Appln. No. 10/775,731

FOR: A CONFIGURABLE VOLTAGE GENERATOR

**BRIEF FOR EX PARTE APPEAL**

FIG. 4A  
PRIOR ART

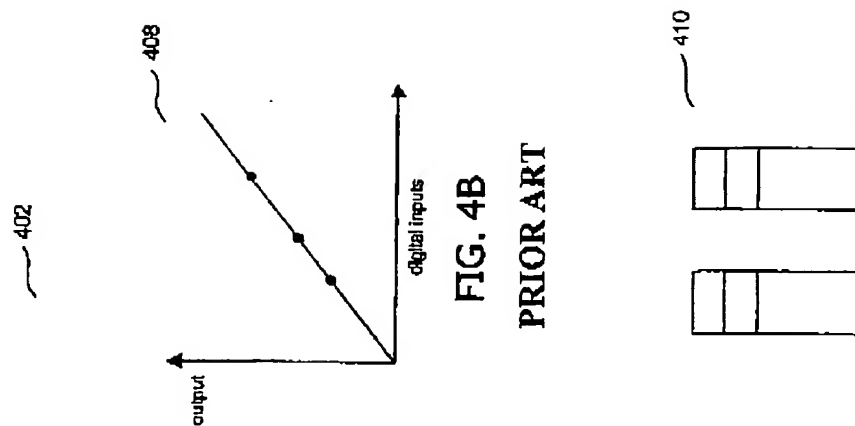
Applicants amended the specification in an Amendment filed May 23, 2005. The Examiner objected to the amendments to the specification, under 35 U.S.C. § 132, alleging that the amendment introduces new matter into the disclosure and has further required the applicant to cancel the new matter. The Examiner further objected to the addition of an output capacitor in Fig. 4a, as adding new matter.

Support for the claims is found on page 7 of the specification. As originally filed, the specification states that “FIG. 4A illustrates a typical n-bit D/A converter, which transforms binary inputs into an analog equivalent. . . .” [0028]. Fig. 4A as originally submitted depicts a prior art D/A converter of the charge redistribution type. This figure is identical to the configuration of Fig. 4-23 of Razavi p. 75, excerpts of which were attached to the applicant’s May 23 amendment and response. Razavi refers to Fig. 4-23 as “a typical capacitor DAC.” Hence that DAC circuit and its operation of converting digital to analog signal levels were well known in the art. Moreover, the output capacitor that applicants had added to Fig. 4a to clarify the DAC’s operation is not necessary for that purpose, and was not required to enable one of ordinary skill in the art to practice the claimed invention. Razavi, Fig. 4-23 does not show such a capacitor, and the DAC 306 sees the capacitance of output capacitor 312 for the full circuit (Fig. 3A). Thus the DAC’s operation is enabled without the addition of a capacitor between elements 306 and 310.

Attorneys for the Applicant canceled the subject matter in a telephone interview with the Examiner. Therefore, the subject matter to which the Examiner objected is canceled, and the objection under 35 U.S.C. § 132 should now be withdrawn.
